From: Eoin Lucey <Eoin.Lucey@mwp.ie>
Sent: 05 October 2016 11:22
To: Martina Gallagher
Cc: Jimmy.king@fisheriesireland.ie; Edwin Mooney; Matthew McLoughlin; Pat Parle
Subject: RE: Courtown Basin Dredging Foreshore Application - FS006403
Attachments: 15193-Foreshore Application-Response to Trench Queries.pdf

From: Martina Gallagher - (DECLG) [<mailto:Martina.Gallagher@environ.ie>]
Sent: 22 June 2016 16:58
To: Pat Parle
Cc: Jimmy.king@fisheriesireland.ie; Edwin Mooney - (DECLG); Matthew McLoughlin - (DECLG)
Subject: RE: Courtown Basin Dredging Foreshore Application - FS006403

Re: DECLG file ref FS0006403 Application on behalf of Wexford Co. Council for maintenance dredging of the basin area within Courtown Harbour, Co. Wexford.

**Project Methodology Outline –
Response to IFI Queries**

Refer to attached Dwg 15193-5011-A.

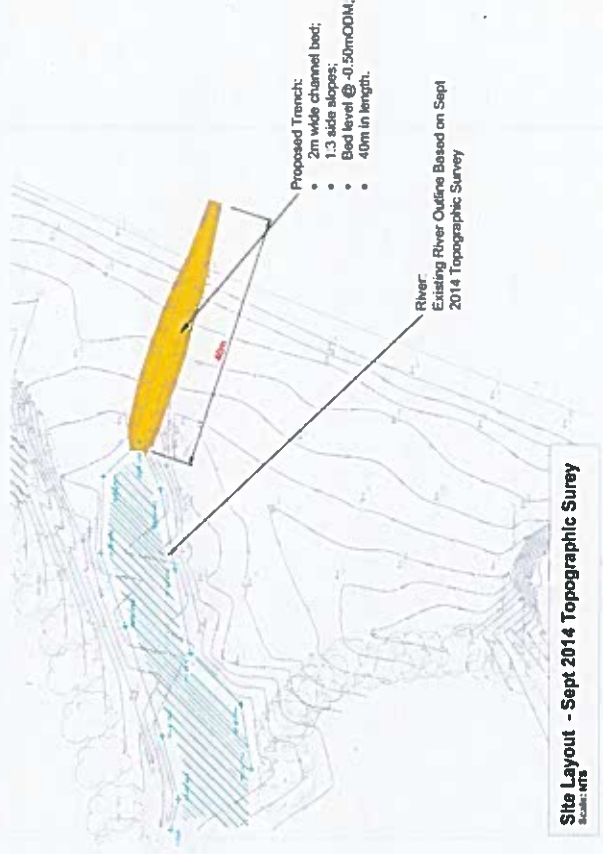
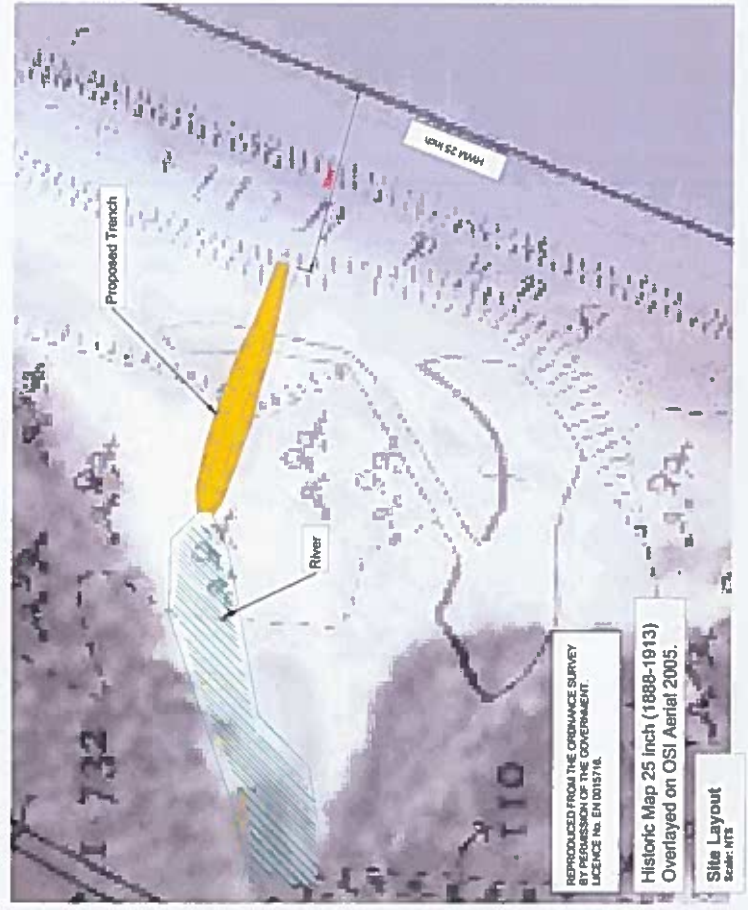
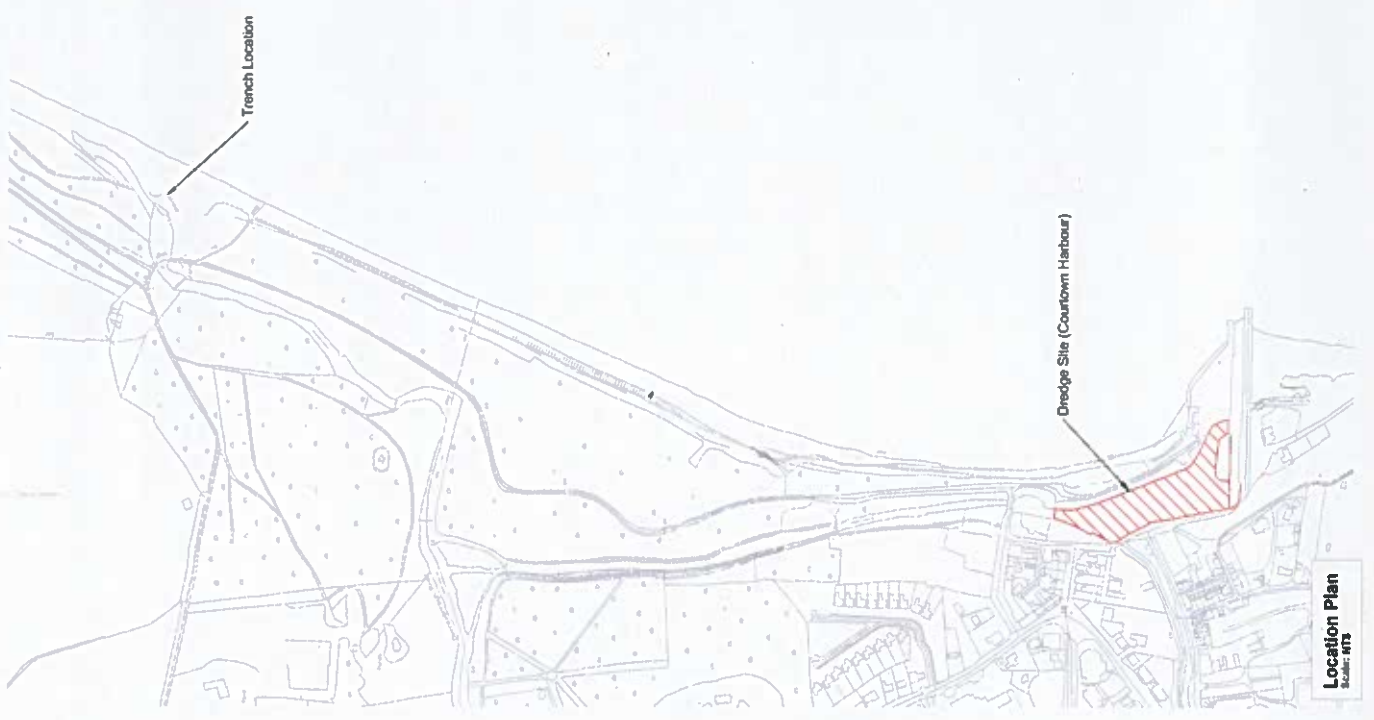
1. Location map of the proposed trench;
2. Methodology for the digging of the trench and
3. Detailed description of how this differs from the previous application.

1. Location Map of the Proposed Trench

The proposed trench will be excavated by means of an tracked excavator. The existing bed level of the river at the beach is at approximately -0.25mODM. The existing river mouth is blocked by the beach sand which reaches a maximum level of +0.75mODM. The trench channel bed will be cut to -0.50mODM through the beach sand until the equivalent depth is reached on the seaward side. Mean Low Water Springs at Courtown is at -0.48mODM. The proposed channel depth will allow passage of fish at all times through the tidal range. The excavator will begin the cut at the closed river mouth and continue seawards. The channel will be 2m wide with side slopes at a slope ratio of 1 vertical to 3 horizontal. The channel will be 40m in length. The contractor will maintain the open cut for the duration of the period for which the basin is closed.

The initial application did not initially address the issue of fish accessing the river in this way. When the issue was raised by the IFI it was mooted that pipes be used to provide access to the river for the fish ("Project Methodology Outline – Response to IFI Queries 21.03.16"). The proposed pipes had a cross sectional area 1.5m^2 . A trench would have been cut to place these pipes which would then be covered over again for the duration of the works. The revised proposed works provide better access for fish passage.

Dwg 15193-5005-B attached.

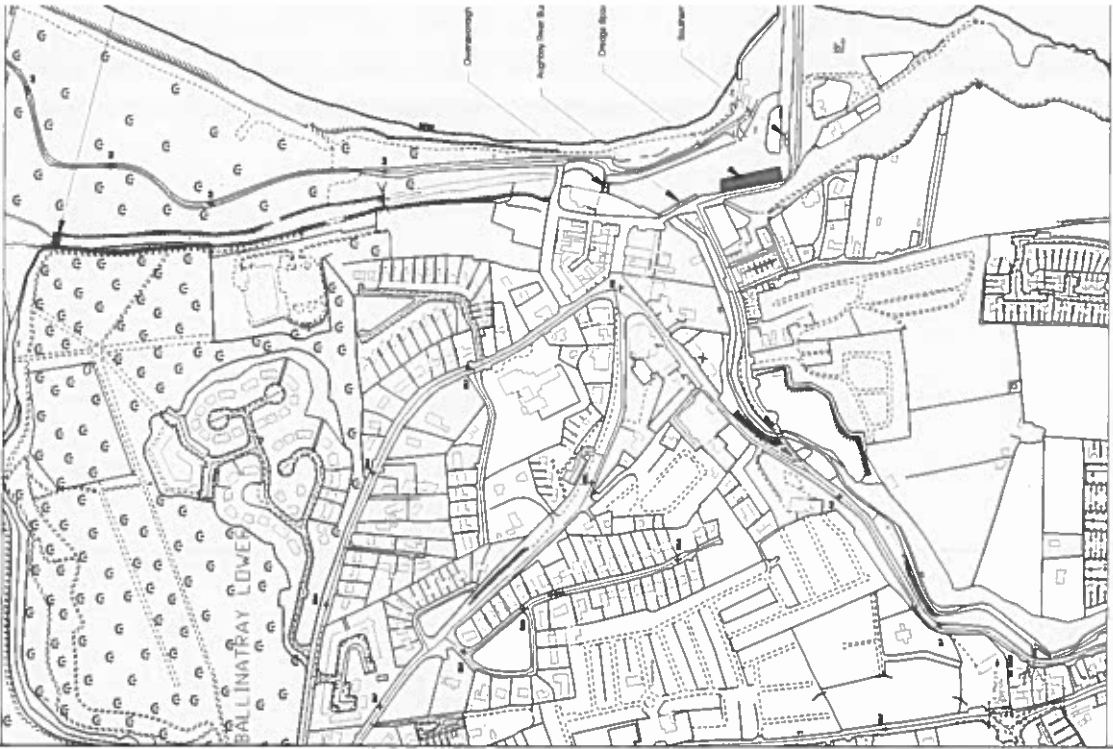
It is not explained where this pipe is to be located or how it is to be placed. Would this work be on the foreshore and be additional to the current foreshore licence – requiring a revised application? IFI requires a clear understanding on this issue of re-routing of the river and of free access for fish.

I have reviewed project methodology and a concern that I would have is the proposed location of the sump trench, from which it is proposed to remove the majority of the fish.

Once fish have been removed I would have no problem with the proposal to deposit the dredge spoil along the harbour wall in the south-western corner as laid out in drawing 15193-5005.

The report refers to contingency plans if the barrier to the harbour overflows and fish re-enter the harbour area. It is important that such contingency plans exists for the Owenavorrigh River Barrier no.2 and for the harbour mouth barrier.

1. The Owenavorrhagh River offshoot is to be blocked at junction between it and the original river way. This blockage point is shown as "Owenavorrhagh River Barrier No.1" on the accompanying drawing. The temporary barrier is to be constructed of one tonne sand bags wrapped with PVC liner.

In order to facilitate free passage of fish fauna into and out of the river during the works it is being proposed to Place pipes with a total cross sectional area of 1.5m² to allow the free flow of water to and from the river. It is anticipated that the cross sectional area will be sufficient for fish to enter and leave the river.
